April 12, 1991

B & E

EUGENIE BRINE WELLS

CROSS SECTION

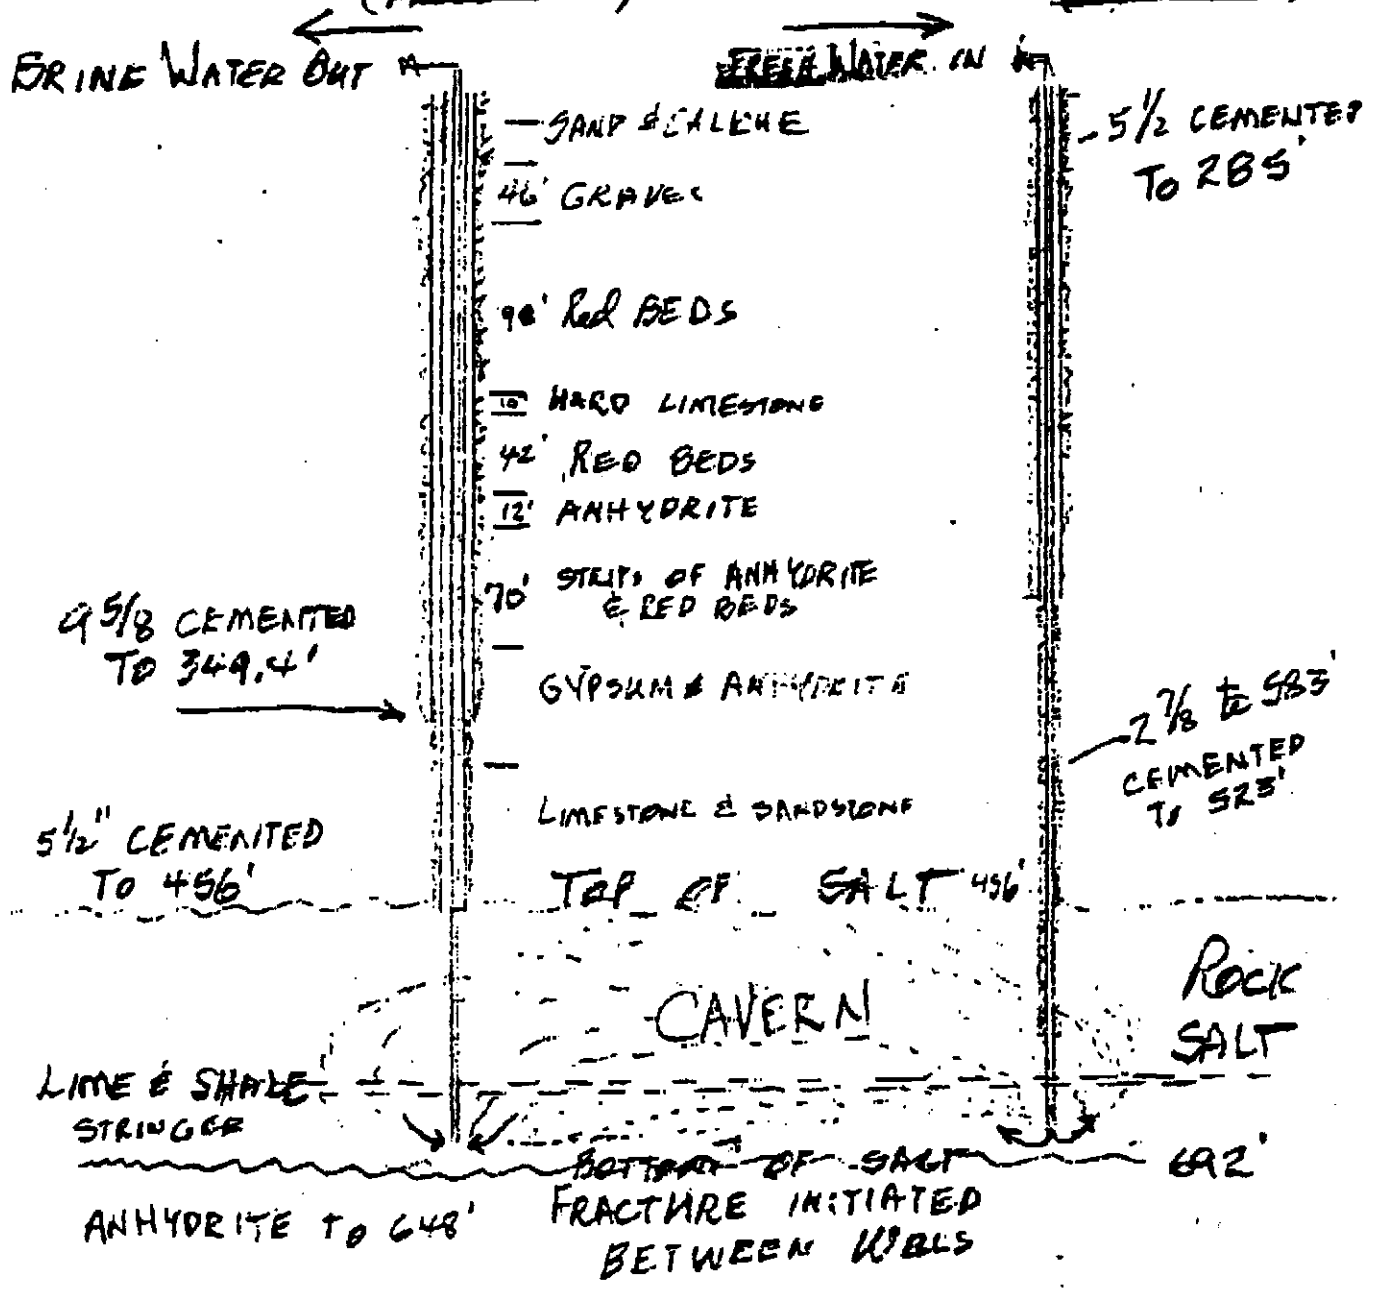
Fresh water is injected down the tubing (set at 583') of the No. 2 well, circulated through the rock salt section to the No. 1 well, where it is forced up the tubing, set at 587 feet. (Please see attached sketch.)

As the fresh water circulates, it tends to move upward as it moves through the salt. This is because fresh water is lighter than brine, 1.0 SP.GR, as compared to 1.2 SP.GR for brine. However, as the water moves through the brine and along the face of the rock salt, it becomes more saturated until it reaches complete saturation. It has been found by research that the cavern formed by the dissolution of the salt well is roughly triangular in shape, being somewhat larger in the fresh water end of the triangle.

However, assuming that the cavern is triangular, its dimensions can be calculated. Assuming that 4,250,000 barrels (1,366,000 sold from July 1979 through April of 1983) of brine have been sold - divide by 7 (each seven barrels of brine dissolves out approximately one barrel of cavern) gives a cavern of about 607,142 barrels capacity. Multiply by 5.61 (cu.ft per bbl) gives 3,406,071 cu. ft. in cavern. Divide by 350 feet (distance between wells - 327 feet and some washout) gives 9,731 square feet for cross sectional area of triangle. Divide by $127/2$ (depth of cavern and divide by 2 to get area of triangle) gives a top dimension of caverns to be 153 feet.

In my opinion this is not excessive, based on amount and kind of hard rock overburden at this site. You usually have some warning of danger of caving or sloughing of the roof of the cavern, in the form of minor cavings which would break or bend the 2 7/8" in the No. 2 well.

However, there is always the possibility of major subsidence... In your location, and the degree of liability exposure, I would recommend that you put about 300 barrels of crude oil down the No. 2 well. This crude will float on top of the brine in the cavern and effectively prevent further dissolution of the cavern roof. I would also recommend that serious consideration be given to the drilling of a third well to greatly minimize any danger of subsidence. See attached plat for location.
